EQ152
DUAL 15 BAND
GRAPHIC EQ

31 BAND GRAPHIC EQ

DUAL 31 BAND GRAPHIC EQ

Service Note and Spare Part List

Service Note

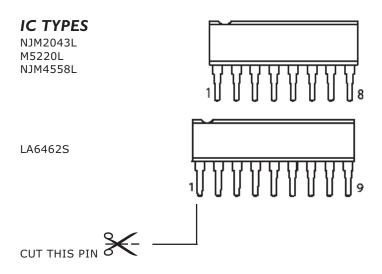
When you order a spare part code 100957 you will receive from GM a NJM2043L or M5220L or LA6462S operational amplifier IC types, all these IC are equivalent with the original mounted IC type NJM4558L, but olny the last one (LA6462S) have a little difference: it has 9 pins instead of 8; to make it pin compatible with the other types you must cut the first pin, the following figure explain how you do it:
